# 566 COLUMBUS AVE., BOSTON SOUTH END LANDMARK DISTRICT COMMISSION

5 MAY 2020

## South End Landmarks Design Review Comments | January 7, 2020

## DESIGN REFINEMENTS

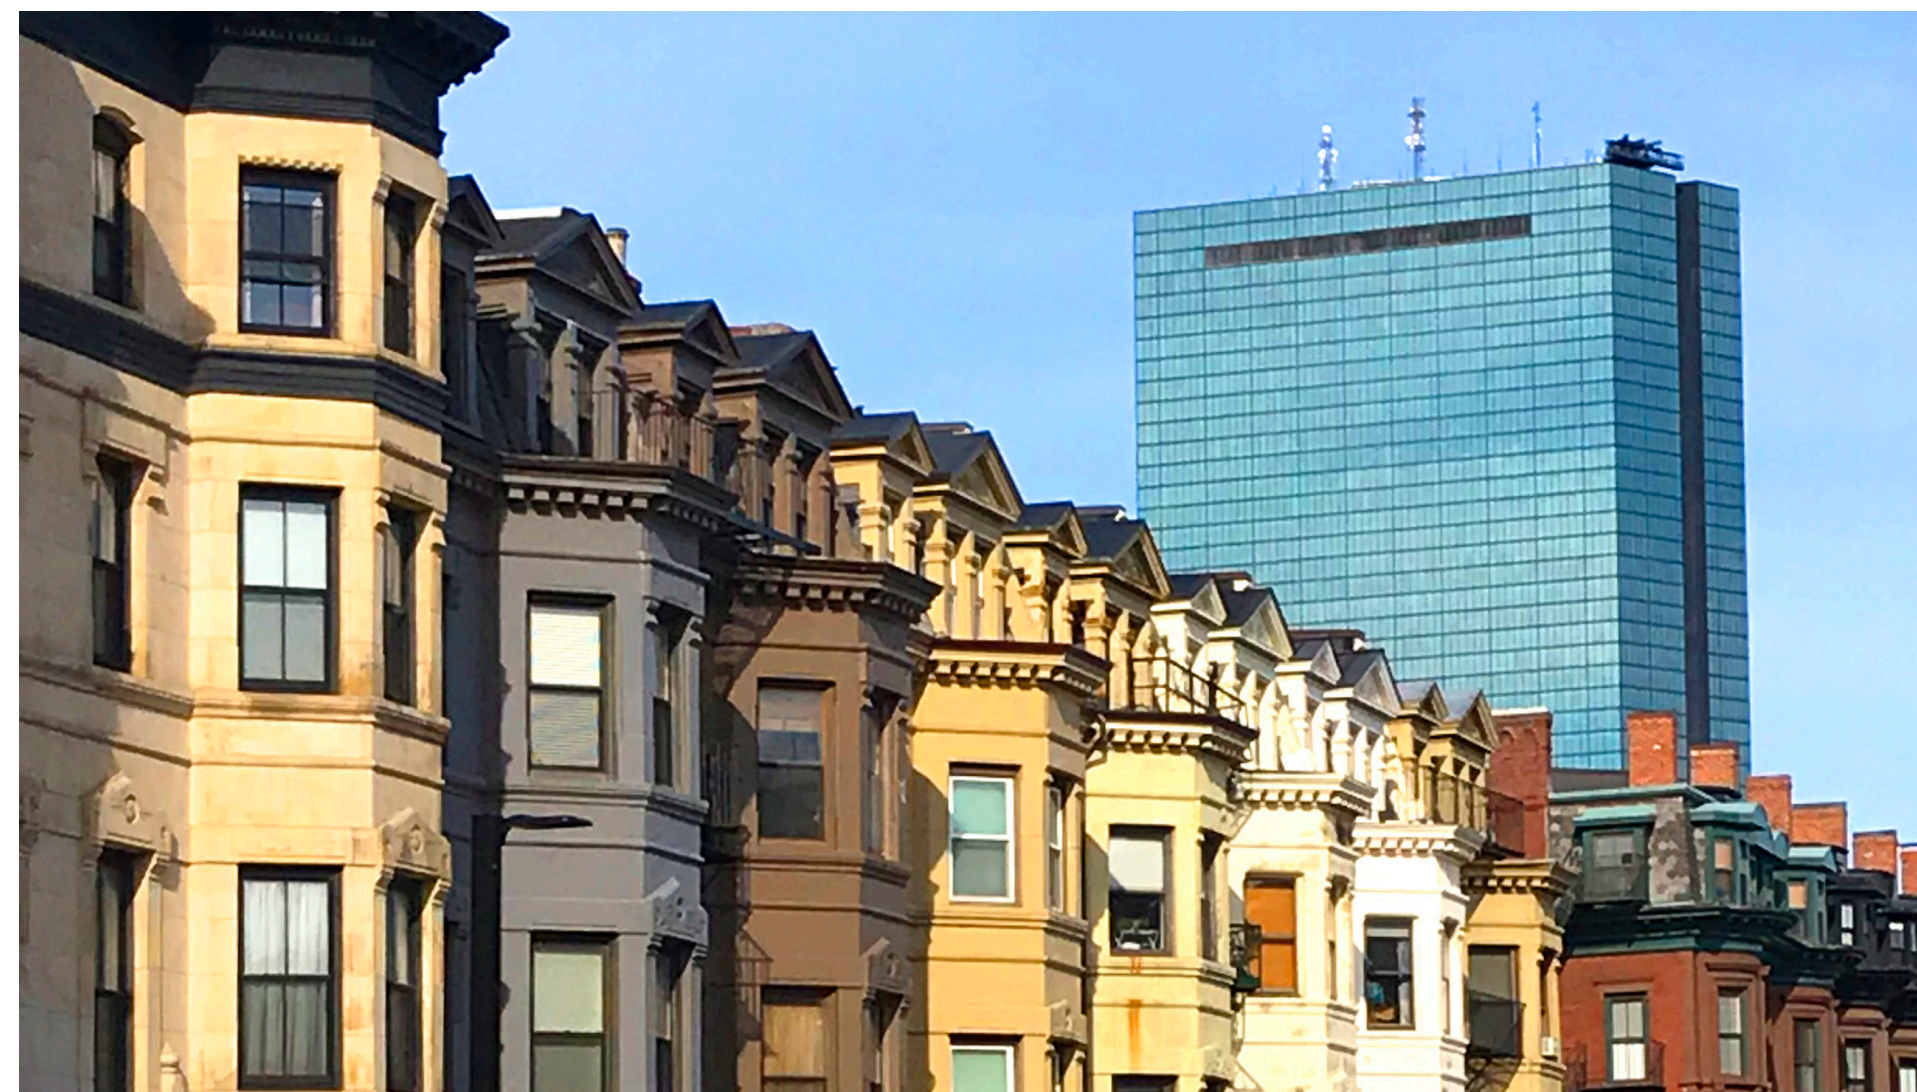
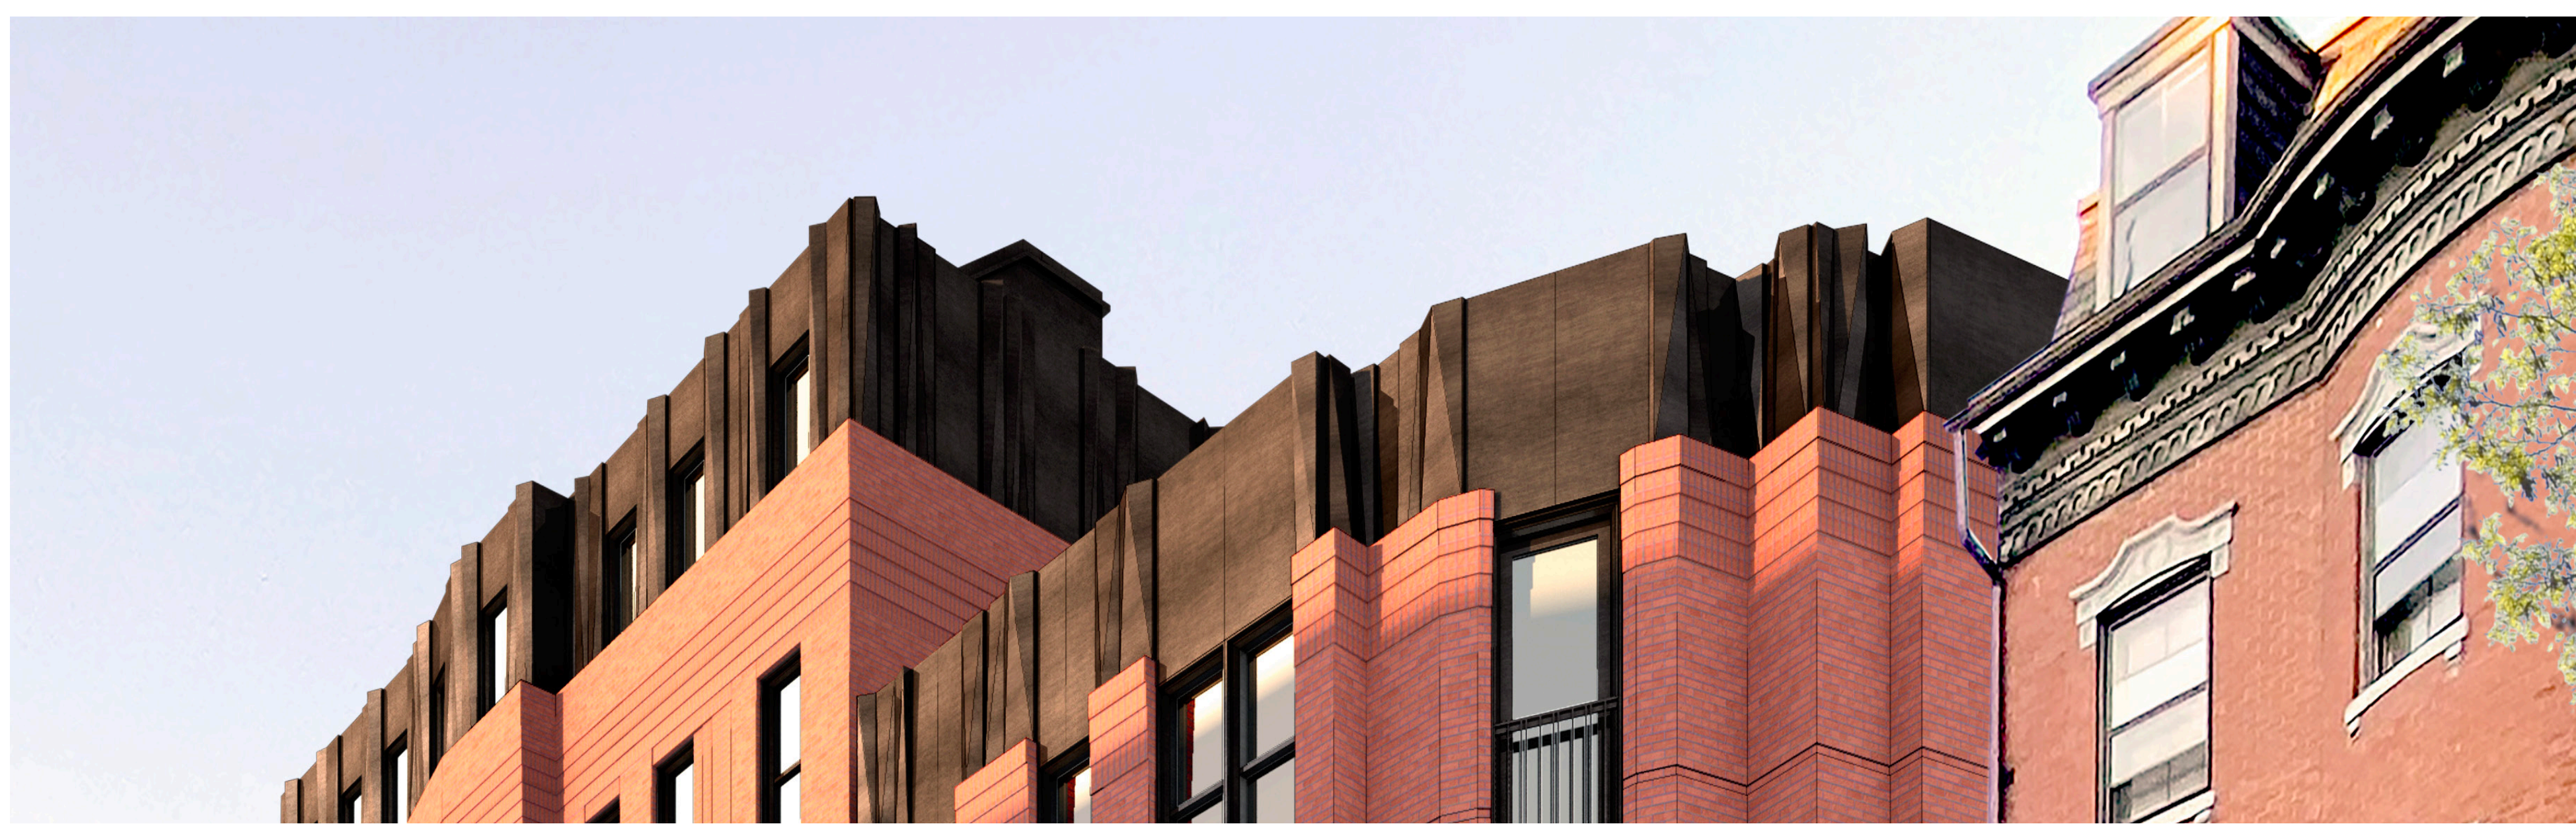
- *The “book-ending” treatment of the corner parcel is appropriate – historically buildings at the corners felt monumental*
- *Articulate window openings, take care in detailing*

- *Façade appears monolithic (flat), the façade should express modulation to break down the massing and read more as a group of residences*
- *Establish a hierarchical language between the vertical and horizontal bands*

- *Study the range of articulation around openings which typically appears more pronounced at entrances and parlor levels and becomes gradually less pronounced toward the upper floors*

- *Consider how this building acknowledges character defining elements consistent of the South End Landmark District; including but not limited to; steel pickets, iron work detailing, brick, metal, oriels, bays*

- *Examine the transitions with abutting buildings – acknowledge established datums of existing/adjacent buildings*
- *Garage door, detailing and visual aesthetic is important*

- *Metal corner composition, detailing and visual aesthetic is important*
- *Look to simplify and add clarity to the overarching moves*
- *Establishing the massing with two different materials is positive*

- WINDOW DETAILING
- RANGE OF ARTICULATION IN PUNCHED OPENINGS UP/DOWN THE FACADE
- COMPOSITIONAL MODULATION ALONG THE FACADE
- HIERARCHY: VERTICAL AND HORIZONTAL BANDS/BRICK DETAILING
- FACADE MATERIALITY AND COLOR
- TREATMENT OF ATTIC STORY / METAL DETAILING
- GARAGE DOOR
- STONE VENEER CLADDING AND GROUND LEVEL BASE CONDITIONS
- METAL CORNER ELEMENT, COMPOSITION AND DETAIL
- CHARACTER DEFINING ELEMENTS;
  - steel pickets/railings
  - brick masonry
  - metal
  - cornices
  - oriel windows
  - proportions & locations of openings
